SDP-24-01 / Arden Residential Care Facility

1st Submittal

Planning/Zoning Comments

Sht C0.00 / General Notes

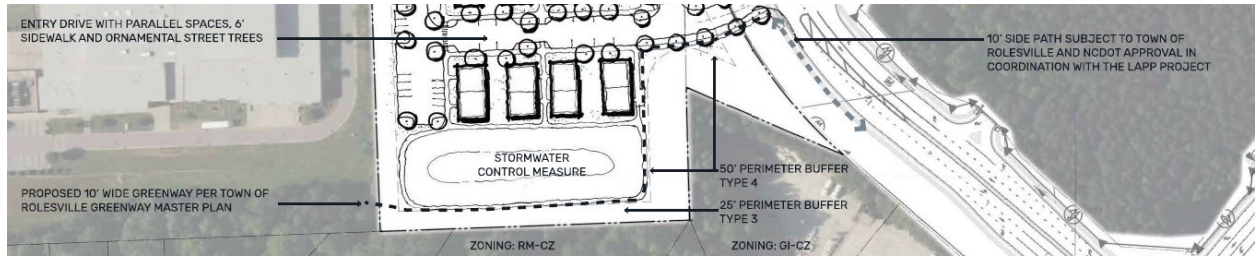
6. Please include the updated FIRM panel number.
7. Please provide a status on the completion of a delineation and receipt of JD from USACE.
